January 25, 2012

**Subject: Advanced Clean Car Regulations**

**Subject: LEV III ISOR – Proposed Changes to Criteria Regulations**

#### G. ARB's E10 specification requires a change to the proposed Total Oxygen wt. % (Appendix D Part II, Sec. 100.3.1.2., at II-3-4).

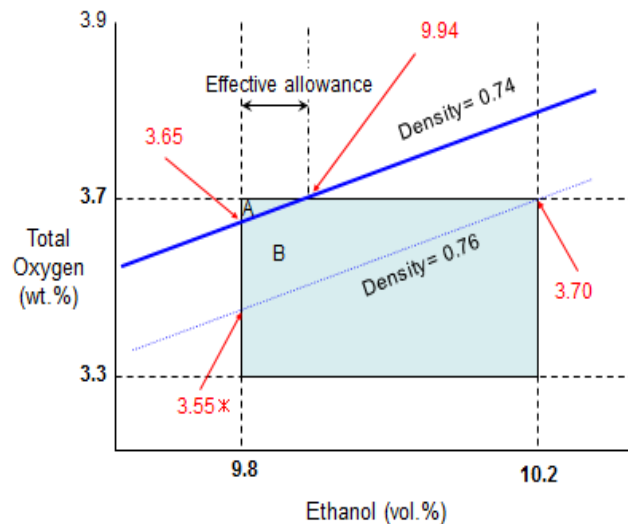
If the density is 0.76, the effective oxygen content is truncated to 3.55 to 3.7% by weight (see Area A plus B below). This effectively caps the lower oxygen content at a number much higher than the proposed specification. **ARB should change the lower limit from 3.3 to 3.5, and the upper limit from 3.7 to 4.0 wt. %.**
